Service Bulletin #5

June 7, 1977

CP300/400

WARBLE ON SSB

SMO BOARD
7H015

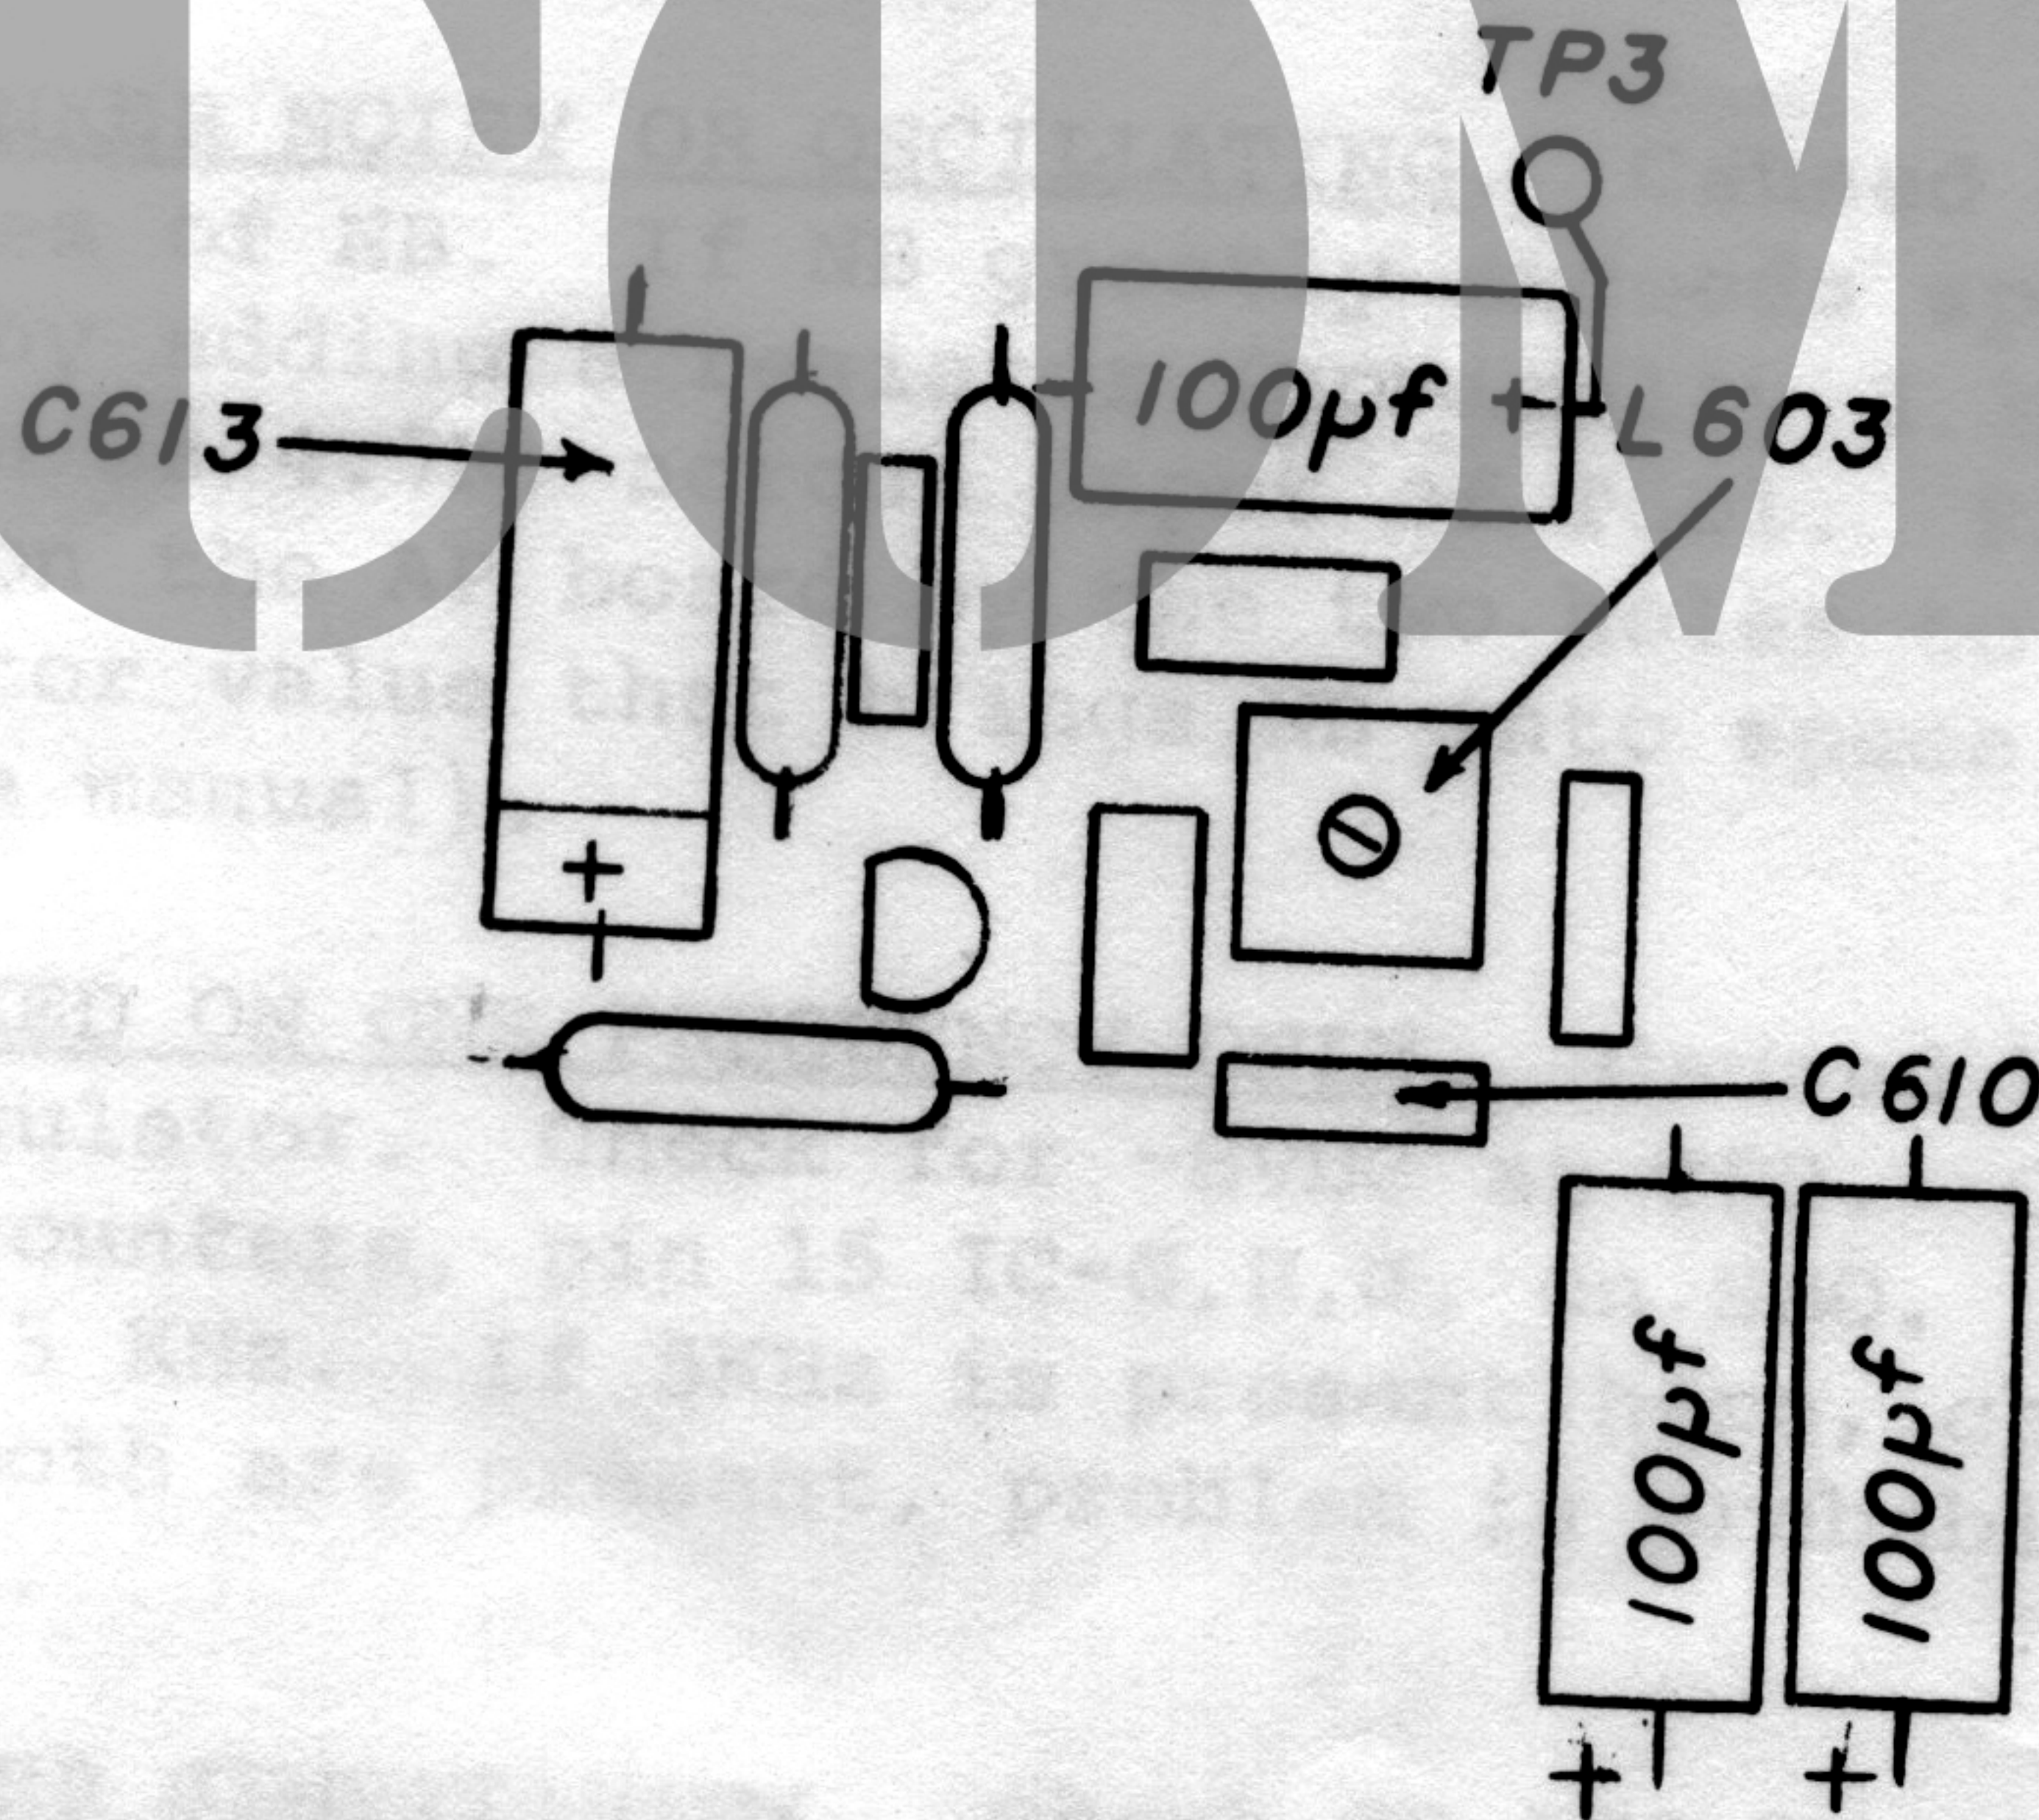
A warble on SSB, often described as "talking under water" or FM'ing on transmit can generally be cured by a simple capacitor change. The following procedure describes this modification. This change is incorporated on current production radios.

1. Change C610 on SMO (7H015) board from a .01 disc to a 68 pf disc capacitor. This capacitor is located directly in front of the VCO coil (L603). See drawing.
2. Change C613 from 10 μ f to 220 μ f. This electrolytic cap is located to the left of L603. See drawing.
3. Reset VCO coil (L603). With channel knobs on 0 0, set L603 for 2.5 VDC at TP 3.
